Technical Memorandum

To	Angus Walker	Contact No.	-
Copy to	Andrew Byrne	Email	-
From	Matthew East	Project No.	12578580
Project Name	DFDS Traffic Impact Study - Immingham		
Subject	IERRT – DFDS Written Response Addendum – Annual Throughput and Terminal Capacity

Figure 1 Example Daily Variations

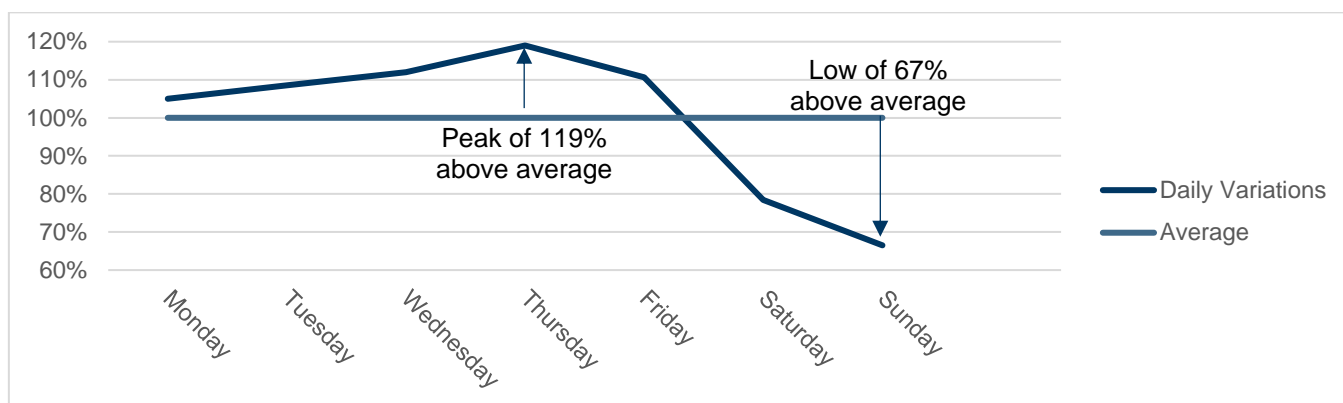
Figure 1 and Figure 2 provide an example profile of these daily and weekly fluctuations for goods passing through the DFDS terminal.

Figure 1 indicates a daily range of between 67% up to 119% of the average volumes. Figure 2 indicates a range of 82% up to 109% of the average volumes. These two figures need to be combined as the daily fluctuations occur within a week, meaning that for DFDS operations at the Riverside facility the total fluctuations can range between 55%, up to 122% of the yearly daily average. If these ranges are applied to the IERRT annual volume of 660,000 RoRo units as quoted within the dDCO, the true daily peak volume (without adjustments for tractor only movements (refer to DFDS response to Action Point 12 from ISH2⁵), and other factors) would equate to:
